STATE OF CONNECTICUT  
CONNECTICUT SITING COUNCIL

IN RE: :  
: :  
APPLICATION OF CELLCO PARTNERSHIP : DOCKET NO. 482  
D/B/A VERIZON WIRELESS FOR A : :  
CERTIFICATE OF ENVIRONMENTAL : :  
COMPATIBILITY AND PUBLIC NEED FOR : :  
THE CONSTRUCTION, MAINTENANCE AND : :  
OPERATION OF A WIRELESS : :  
TELECOMMUNICATIONS FACILITY AT 917 : :  
EXETER ROAD, LEBANON, CONNECTICUT : APRIL 18, 2018

**RESPONSES OF CELLCO PARTNERSHIP D/B/A VERIZON WIRELESS  
TO CONNECTICUT SITING COUNCIL PRE-HEARING INTERROGATORIES**

**Site Schematic**

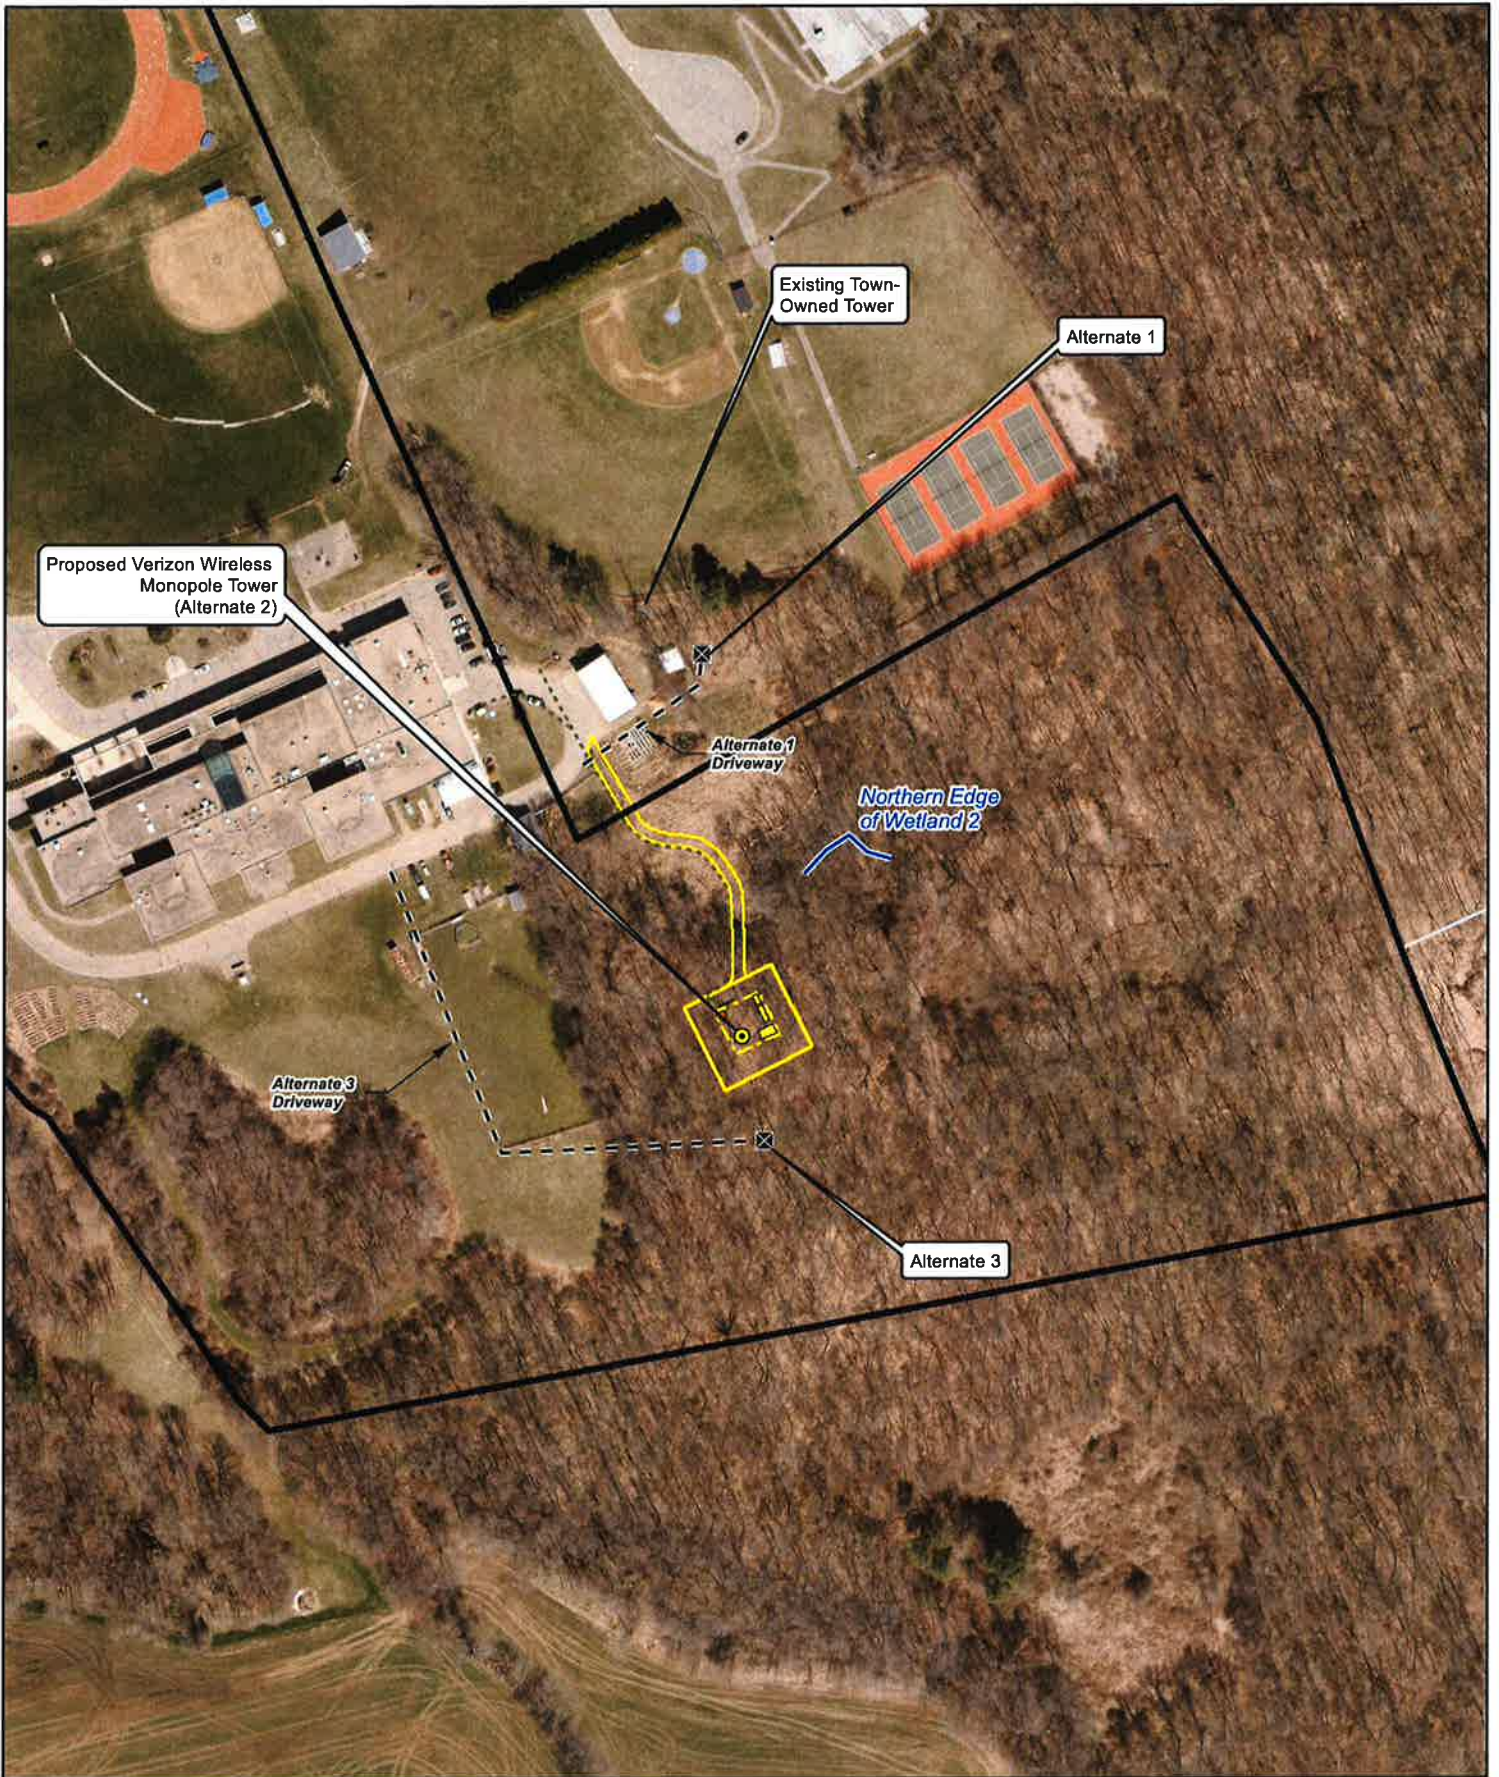
Referring to Application p. 23, what were the other two locations on the property that were considered for a tower site? What were the reasons for their rejection?

Could the tower site be relocated to the area east of the agricultural field and north of Wetland 2?

Two alternate tower locations were investigated on the subject property. These locations are depicted on the Site Schematic map provided in Attachment 1. The northern-most tower location (identified on the map as Alternate 1) was rejected due to proximity to the recreational fields to the north, lack of screening to the high school to the west, and potential future use of this area as part of the High School's agricultural programs outdoor classroom expansion. Town of Lebanon staff indicated that an orchard was planned in that area. The second alternate tower location evaluated was to the south of the proposed Facility (identified on Attachment 1 as Alternate 3). This location was rejected primarily due to conflicts with the existing agricultural fields used by the High School's agricultural education program along with concern over the longer access and increase in mature tree removal.

As noted in Question No. 8 response, an alternate tower location was evaluated in the general area east of the agricultural field and north of Wetland 2; refer to the location labeled Alternate 1 on the map provided in Attachment 1. The Alternate 1 site is not considered a favorable tower location due to the reasons provided in Question No. 8 response. If the Alternate 1 site location was shifted further to the east it would encroach upon an existing woods trail maintained and used by the Town school system as a recreational trail. As a result this location was rejected from consideration.

**Forest Fragmentation Map**

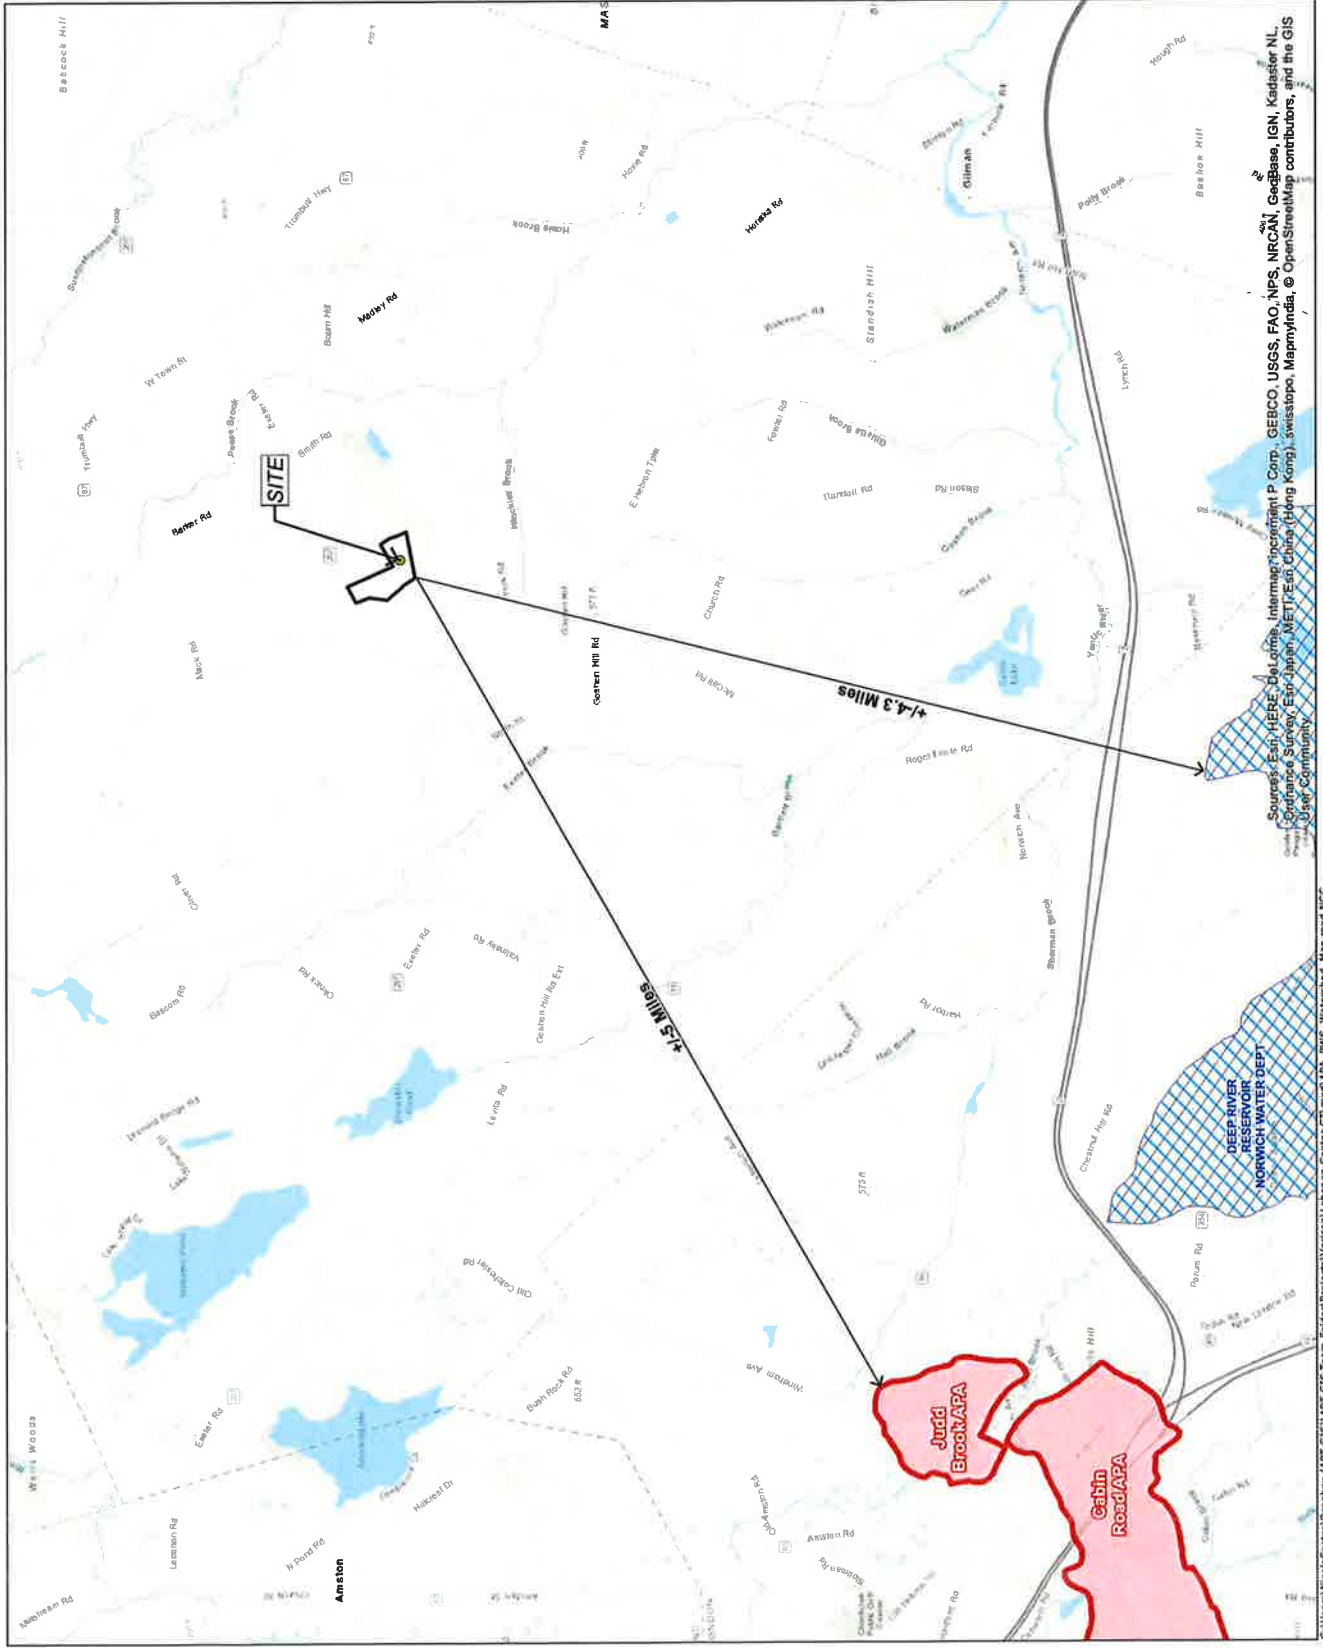
Would site development affect core forest? (refer to C.G.S. §16a-3k for core forest definition)

called edge width.<sup>1</sup> Core forest areas are sub-classified into three categories – small core, medium core, and large core – based on the area of a given core patch: large core forest = >500 acres; medium core = 500 – 250 acres; small core = <250 acres. Based on this forest block classification tool, the subject property forest is classified as an Edge Forest Block (±77.3 acres) and Small Core Forest (±62.7 acres) as a result of the on-site and surrounding institutional developments, agricultural land use and roadways that have fragmented the core forest block. Refer to the Forest Fragmentation Map provided in Attachment 2.

Development of the Facility will result in ±0.18 acre of forest removal (12 trees would be removed) within the Edge Forest Block which represents ±0.2% of the total Edge Forest Block. Therefore, since the proposed Facility would not result in fragmentation of a core forest block and clearing would be limited to a de minimis loss of trees in the Edge Forest Block, no significant change to the overall nature and function of this forest habitat would occur due to the proposed development.
